Subject: Application 161095, 1417 Harper Street, APN 026-531-13. Report back to the Planning Commission of the final amended road/parking layout following review of a reduced road width by DPW and Fire.

Plan Review Comments from DPW and Fire

161095 - Proposal to divide an existing 24,505 square foot parcel into three residential parcels and a common Page 2 area parcel and to construct three residential dwelling units

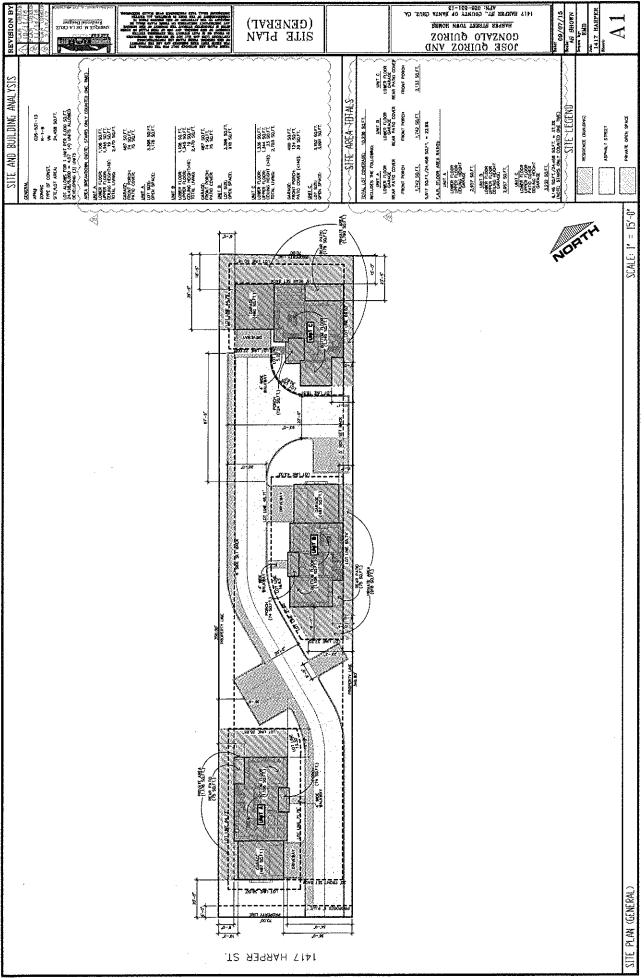
The proposed reduction in the width of the road was not acceptable to DPW, Road Engineering, because the narrower road width would reduce the available back out distance behind proposed parking spaces and cause a "huge problem". Jack Sohriakoff pointed out that the required back out space is typically 26 feet but stated that using a 24 foot driveway is deemed sufficient.

Yes, the backing out would be a huge problem. The required back out space is typically 26 feet, but using a 24 foot driveway is deemed sufficient. A reduced driveway to 20 feet is not acceptable. Also, where is the parking spot to be removed? There is always parking wars in residential neighborhoods. Why start one here?

It should work. My concern is at the driveway approach at Unit C. Provided that it is constructed to meet the same weight requirements, it should suffice.

They will have to go back through Central Fire, but I do see an issue with the turnaround. It does not meet the required dimensions.

Based upon comments received from DPW and Fire, a revised plan that includes a driveway/road that has a reduced width of 20 feet could not be approved due to the need to maintain an adequate back out distance behind the parking spaces and driveway entrances. Therefore staff recommends that the driveway/road be approved with a width of 24 feet, in conformance with County Code section 13.11.074(A)(1)(f) and as originally proposed.

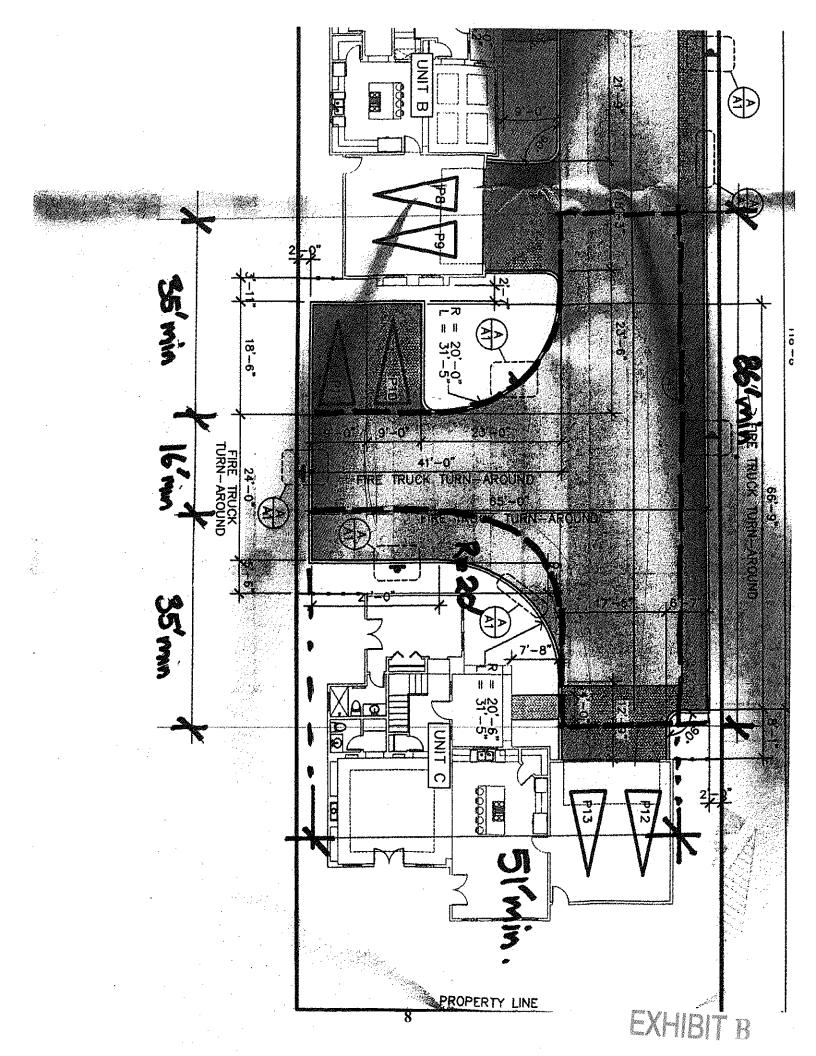
Does this work? I think that the turnaround is there but just incorrectly dimensioned. If you think this is OK I will let the applicant know to show the actual turnaround dimensions on the final plans.
